GFA AIRWORTHINESS DIRECTIVE

- SUBJECT:** Flight Controls, Control column Rod end inspection / Replacement
- REASON:** During a pre-flight inspection of a DG-100 sailplane the adjustable Rod End of the aileron pushrod was found broken at the control column end. Early DG aircraft were fitted with rod ends manufactured from a standard grade steel. This is to be replaced with one of high grade steel, identifiable by an "X" stamped on the shank.

Technical note
No. 301/25, 323/16

Subject : Rod end in control column

rod end

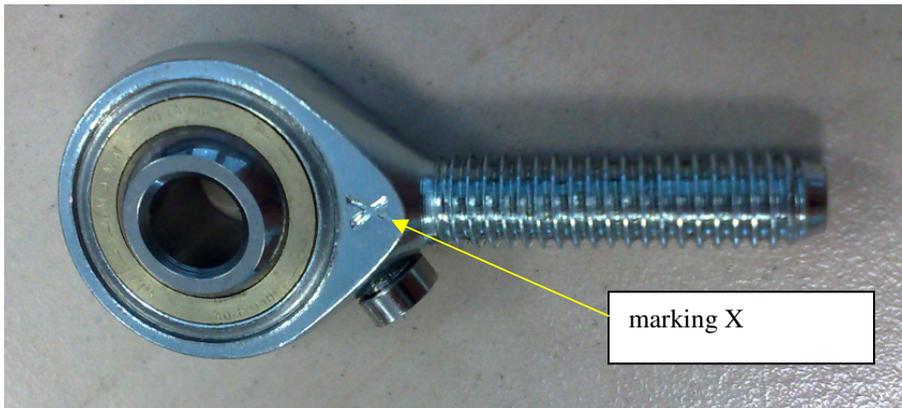
Inspection with a mirror, no X is existing, rod end must be replaced.

Instructions : 1. a. Remove the control column boot and check if the rod end is marked with an X. If the X is not visible from the top look with a mirror from the underside see photo 2.
If the rod end is not marked with an X and no damage or cracks are visible the glider may be operated with this rod end up to the execution of instruction 2.
b. If any damage was detected the rod end must be replaced prior to the next take-off.
2. Exchange the rod end against a new one marked with an X. Use a new self locking-nut.
